### **IN THE DRAWINGS**:

#### **REMARKS/ARGUMENTS**

Filed: 11/24/2003 Serial No.: 10/721,110 Docket No.: 2269-3437.9US

Fig. 1 (PRIOR ART)

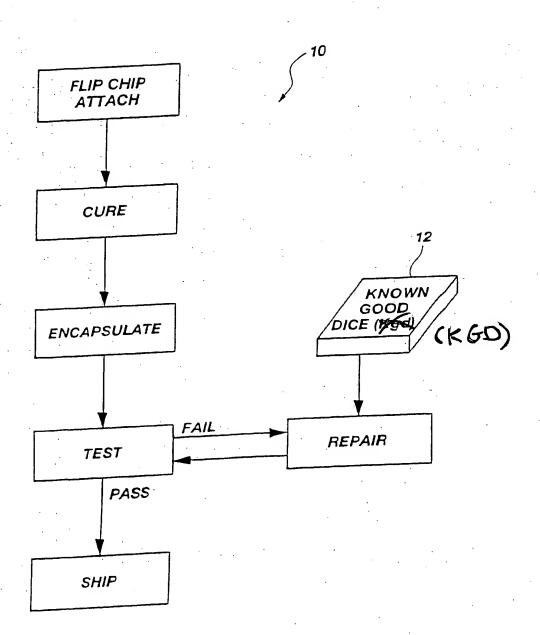
The attached sheets of drawings include changes to FIGS. 1 and 3. These sheets, which include FIGS. 1 and 3 only, replace the previous drawing sheets submitted for these Figures. In FIG. 1, the acronym for "KNOWN GOOD DICE" has been changed from (Kgd) to (KGD). In FIG. 3, "IN-SITU TEST SOCKET" has been changed to "IN-LINE TEST SOCKET." (See attached Replacement Sheets and Annotated Sheets Showing Changes.)
